**Response To Comments**  
**on the**  
**Draft and Recirculated Environmental Impact Analyses**

**Prepared for the**  
**Amendments to the Low Carbon Fuel Standard**

**California Air Resources Board**  
**1001 I Street**  
**Sacramento, California, 95814**

**Released November 6, 2024**  
**to be considered at the**  
**November 8, 2024 Board Hearing**

**Figure 1: Sources of PM<sub>2.5</sub> Emissions Reductions from LCFS Rulemaking**

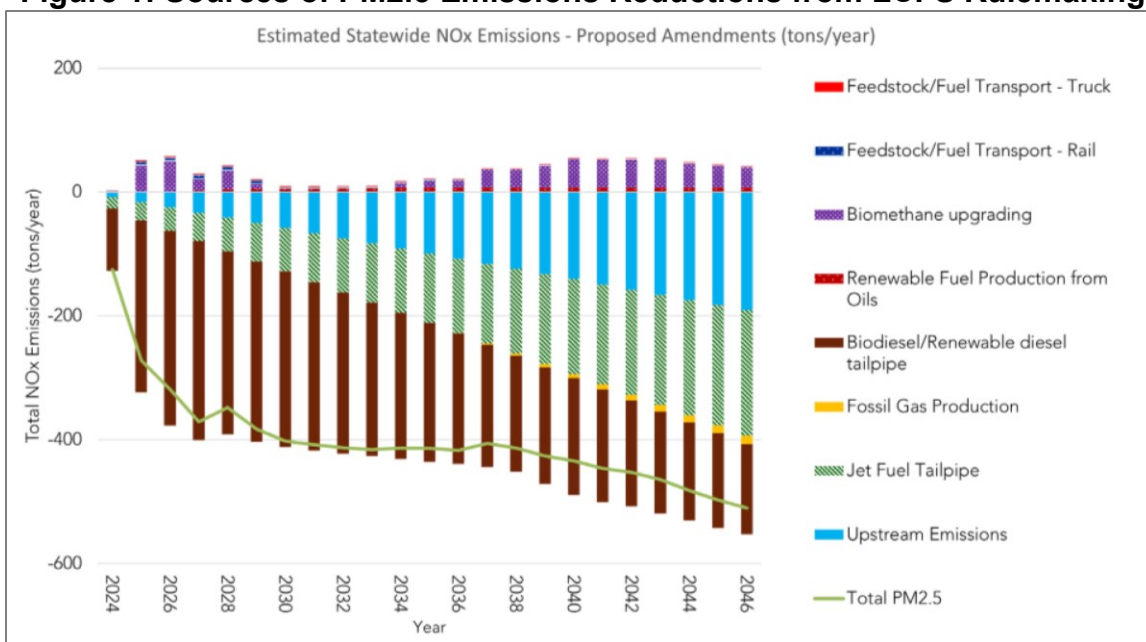
As part of the recirculated draft EIR for the LCFS rulemaking, the air quality impacts analysis conducted by CARB highlights that biomass-based diesel use represents a large majority of the NO<sub>x</sub> and PM reductions from this rulemaking. Figure 1 below shows the RD and biodiesel tailpipe emission reductions represent approximately 50% of PM<sub>2.5</sub> reductions from this rulemaking (see page 52 of the recirculated EIR)<sup>9</sup>.

**Figure 2: Sources of NOx Emissions Reductions from LCFS Rulemaking**

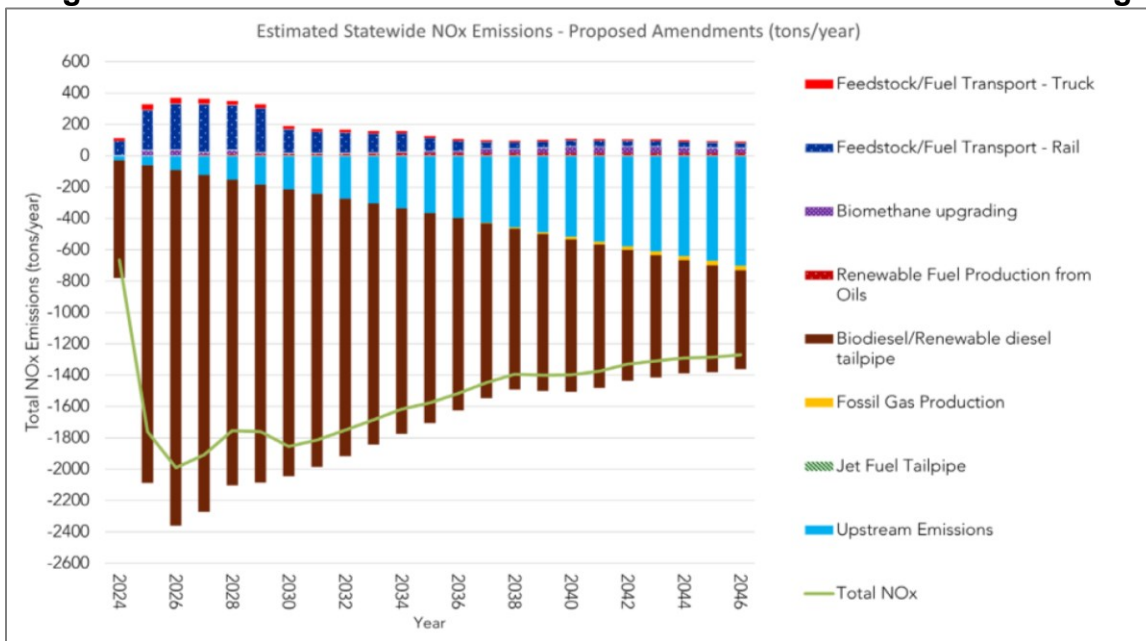
Similarity, CARB's analysis of NOx reductions on page 51 shows that RD and biodiesel tailpipe emissions reductions represent approximately 78% of the reductions achieved by this rulemaking (see Table 2 below)<sup>10</sup>.

**Figure 3: GHG Emissions from Proposed LCFS Amendments and the Baseline**

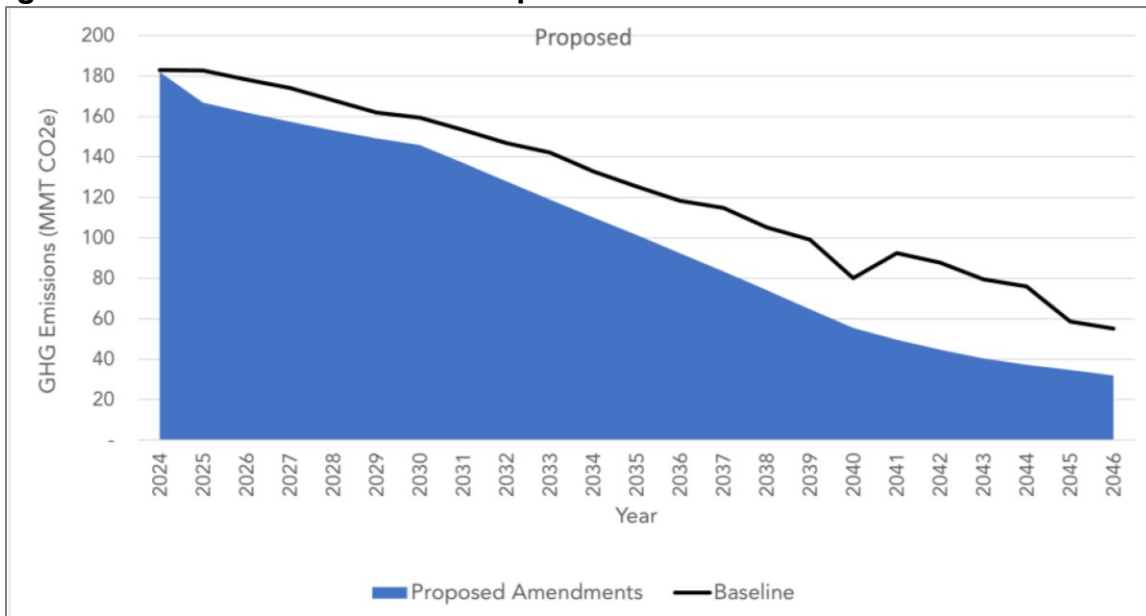
Neste reviewed the data used to generate Figure 3 below, and it appears as though CARB attributed several GHG reductions early into the Proposed Amendments that have no explanation<sup>12</sup>. Examples include lower than expected fossil fuel use in 2024-2026, making the GHG emissions artificially low early into the Proposed Scenario. As noted in our comment

letter for the August 2024 15-day package, CARB is modeling the Proposed Scenario assuming an artificially low fossil diesel volume that is simply not possible (see page 7 of the comment letter)<sup>13</sup>. This resulted in the Proposed Amendments appearing as more effective than the Baseline, even though CARB's own analysis back in just April 2024 would suggest otherwise.

**Response:** Staff calculated the GHG reductions based on outputs from the CATS model, which optimizes the fuel mixture entering the market to balance fuel supply and demand that result in meeting the annual carbon intensity target. The reduction in GHG emissions in the proposed amendments for the Recirculated EIR reflect the following primary differences from the EJAC scenario of the ISOR that was released in April 2024:

**Figure1: Staff February 2023 Workshop Slide Showing Crop-Based Oil Surge**

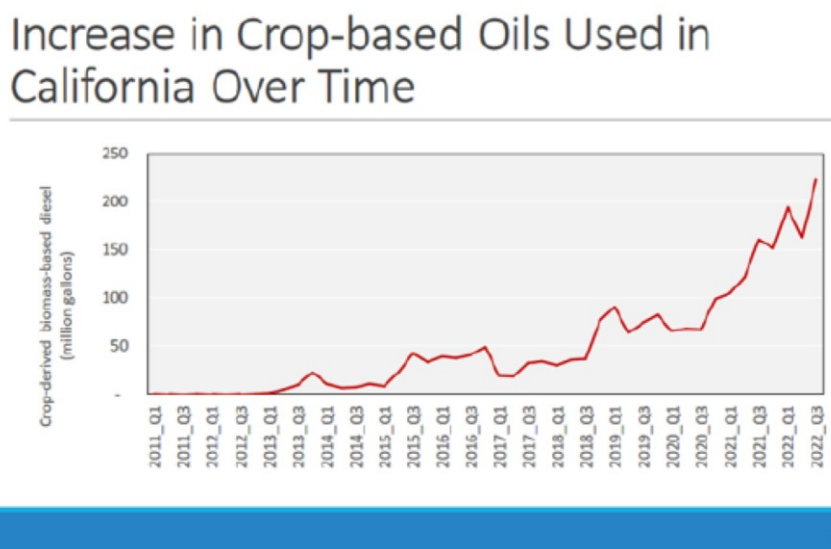
**R22-5:** The commenter states, “As one example of fundamental flaws the RDEIA fails to acknowledge, the land use values used in LCFS currently, as modeled by GTAP, are not calibrated to assess the significant increase in renewable diesel (“RD”) volumes projected under the Proposed Amendments. The DEIA states “[t]he current LCFS regulation uses land use change emissions estimates by feedstock, which were last assessed between 2013-2015” absent any recognition that circumstances have changes in the decade since these estimates were adopted.<sup>5</sup> Registering their significant concerns, the UC Davis Policy Institute for Energy, Environment and the Economy informed CARB that the “[t]he GTAP model simulated a supply shock based on anticipated impacts of the U.S. Renewable Fuel Standard [RFS], as it was structured at the time. They did not account for the rapid growth in lipid-based fuels, nor the more than doubling of Renewable Volume Obligations for biomass-based diesel under the RFS that has occurred since the modeling that informed the LCFS land use change impact values was conducted.”<sup>6</sup> For example, to estimate ILUC emissions, GTAP assumes production of roughly 0.8 billion gallons of soy biodiesel.<sup>7</sup> But as shown in Figure 1, CARB’s February 2023 workshop presentation acknowledged the unprecedented use of crop-based oils in the program, primarily driven by soy, indicating financial or other barriers have been overcome that make using these feedstocks viable, even under increasingly stringent CI benchmarks.<sup>8</sup>

**Figure 2. Renewable Diesel and Biodiesel Volumes Projected Over Time**

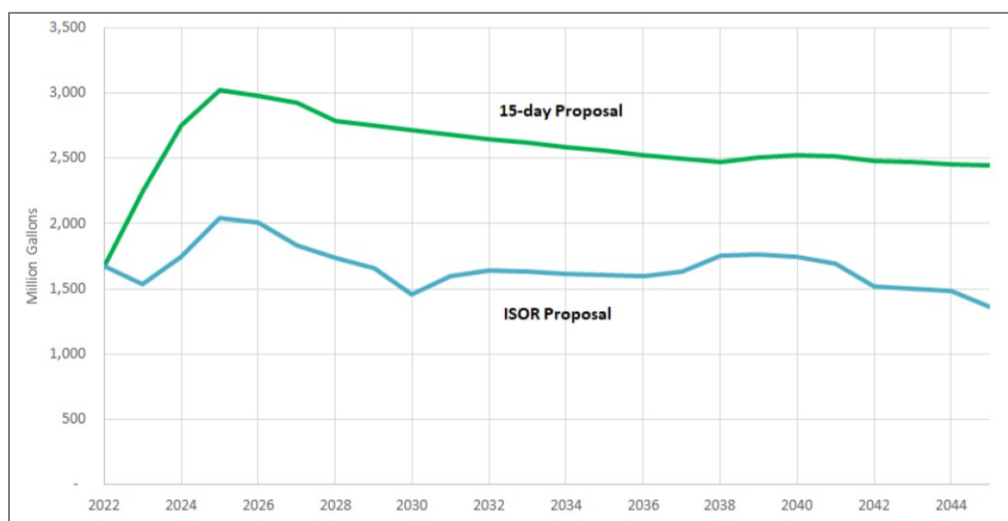
Here, the RDEIA falls far short of CEQA’s mitigation requirements. As an initial matter, CARB largely attempts to shirk responsibility for Project impacts despite Project design being the driving force for these impacts. What few measures CARB does propose are overly vague or ineffectual at addressing the significant impacts from crop-based biofuel production resulting from the Project. Indeed, as shown in Figure 2, the 15-day changes proposed by CARB staff that are the focus of the RDEIA show projected volumes of RD are actually 50% higher than those modeled in CARB’s original proposal, which did not include additional mitigation beyond a 20 percent credit limit on crop-based diesel. The issues related to potential biofuel volume increases were identified prior to the revised projected volumes. The problem becomes all the more immediate under the increased volumes that CARB projects will come into California, as demonstrated in Figure 2.

**Figure 3: Carbon Intensities of ULSD, Proposed Benchmark, and Proposed CI for Biofuels Over the 20% Limit"**

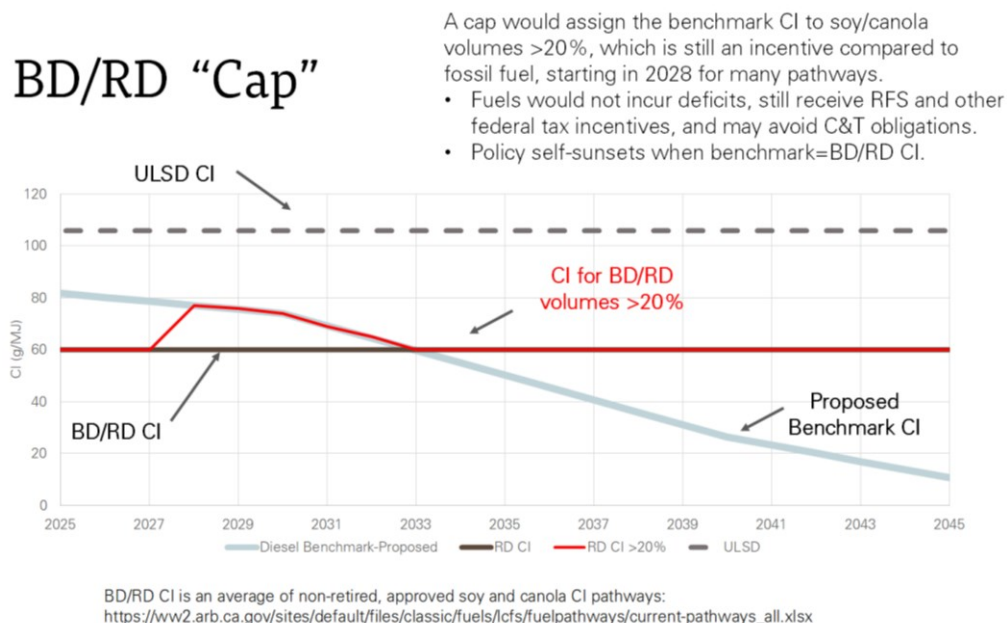
Second, the RDEIA makes the unsupported assertion that "the proposed regulation is not expected to result in significant increases in soy and canola feedstock utilization for biomass-based diesel, given that volumes in excess of 20 percent, which matches 2023 feedstock composition levels across all pathways, will not be eligible for crediting."<sup>51</sup> However, even with volumes above 20 percent assigned to the benchmark CI as contemplated under the RDEIA, producers still have an incentive to deliver fuel to California. They would avoid generating deficits, benefit from higher diesel prices in California, potentially avoid Cap-and-Trade obligations, and continue to receive federal subsidies such as the RFS and Blender's Tax Credit. In addition, due to the proposed auto-acceleration mechanism ("AAM"), the benchmark is likely to equal the CI of RD within three years of it going into full effect. For example, the average of current soy and canola BD/RD pathways is 60 gCO<sub>2</sub>e/MJ. Under the proposed benchmark schedule, RD/BD volumes exceeding 20% would lose a subsidy equivalent to a CI difference of 17 gCO<sub>2</sub>e/MJ, reducing to 9 gCO<sub>2</sub>e/MJ by 2031.<sup>52</sup> Should the AAM be triggered in 2028 and 2030, even this small difference will disappear by 2031.<sup>53</sup> Therefore, the proposed limits provide only a short-term disincentive that phases out as the benchmark CI decreases to match RD's CI. Accordingly, assigning excess biofuels to the CI benchmark does not send a strong enough signal to discourage production and its corresponding impacts. CARB itself recognizes that assigning fuels the ULSD benchmark is an effective deterrent, as it has proposed assigning ULSD to the following: biofuels produced with uncertified biomass,<sup>54</sup> fuels produced with palm or palm derivatives,<sup>55</sup> and RNG used in compressed natural gas ("CNG") vehicles after 2040.<sup>56</sup> The contrast between the effectiveness of assigning the ULSD benchmark compared to the RDEIA's proposed Benchmark CI is illustrated below in Figure 3 below.

**Response:** Please refer to Master Response 2 regarding land use change, resource shuffling, and why the 20% crop oil feedstock crediting limitation is an adequate deterrent from deforestation while still encouraging growth of sustainable, low-carbon feedstocks to displace fossil fuels.

**Figure 5: Fossil Diesel Volumes Under 15-day and 45-day Package Scenarios**

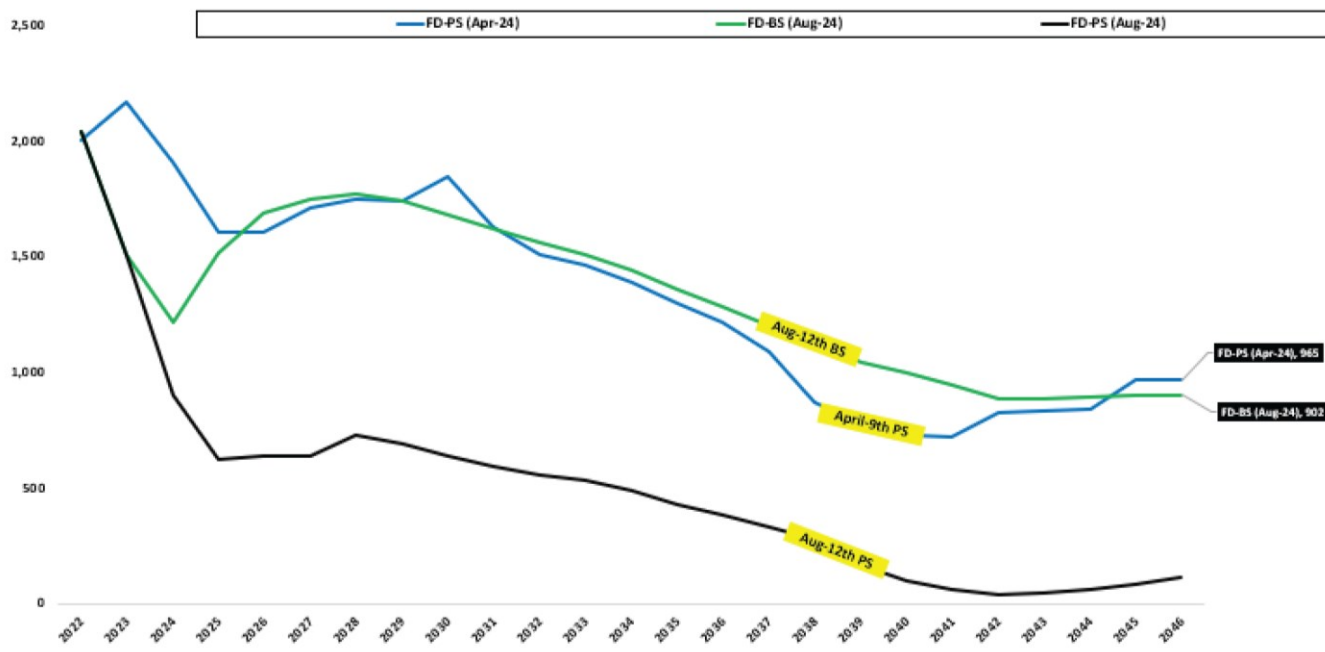
**15.1-228-2:** The commenter states, “Neste strongly believes that this proposal, among several meant to limit liquid renewable fuels, is likely to lead to higher consumption of fossil diesel, as noted by CARB in the April 10th LCFS workshop<sup>16</sup> (see slide 21). However, the modeling CARB presented as part of this 15-day package does not reflect that, making Neste question the accuracy of the environmental analysis for this 15-day package. Figure 5 below shows how fossil diesel fared in this 15-day package, and Neste would expect the April 9th Proposed Scenario (pulled from 45-day package) shown in blue below to be identical to the August 12th Baseline Scenario shown in green below. That is not the case, and there is no explanation for the decrease in fossil diesel use shown from 2023 through 2025 under the August 12th Proposed Scenario shown in black.

This scenario is even less likely than RD usage of 3 billion gallons. CARB's modeling simply does not make sense and the implications are risky negative impacts to the diesel market and other unintended consequences from this 15-day package.
